Rezoning Transportation Analysis

Petition Number: 2022-210

Date	Description
05-24-2023	First Review (PDM)
06-21-2023	Second Review (DR)
08-23-2023	Third Review (PDM)

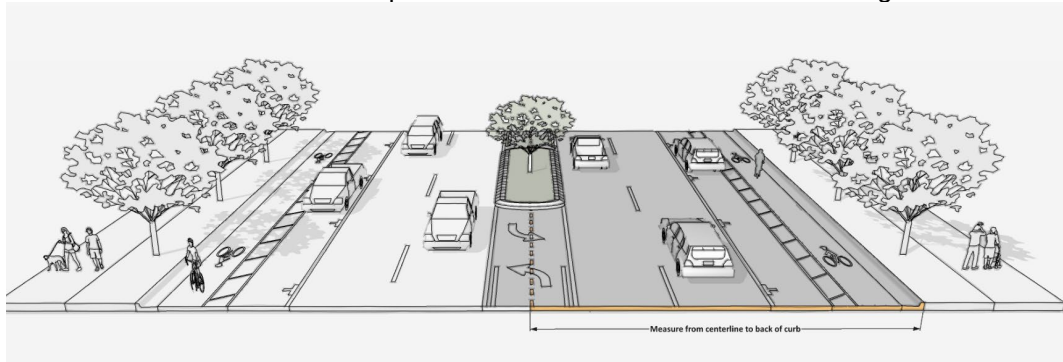
Petitioner to provide responses to the staff comments below as well as specify other changes to the site plan.

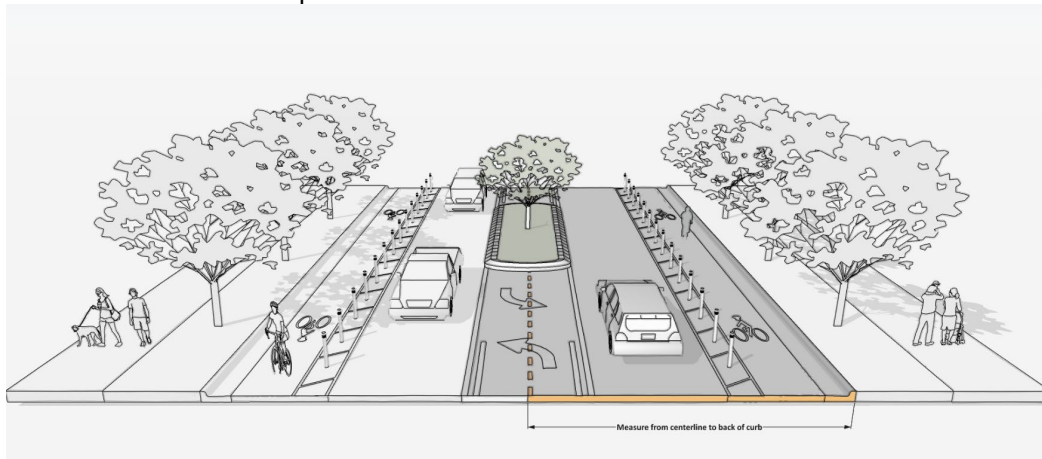
- a. **South Tryon Street:** Location of curb and gutter to be moved a minimum of 42.5 feet from roadway centerline to accommodate the Charlotte Streets Map with a roadway typical section of a 4+ Avenue with Buffered/Separated Bike Lanes and On-Street-Parking.

- b. **Clanton Road:** Location of curb and gutter to be moved a minimum of 27 feet from roadway centerline to accommodate the Charlotte Streets Map with a roadway typical section of a 2+ Avenue with Buffered/Separated Bike Lanes.

NOTE: Additional distance from center line to back of curb may be required in locations where a median and turn lanes are required. Final curblines to be reviewed by CDOT once TIS is approved.

Label and dimension the curb and gutter from the centerline for each road on the site plan.

Clarifying comment 6.21.23: Label and dimension the curb and gutter from the centerline for Clanton Road and South Tryon Street.
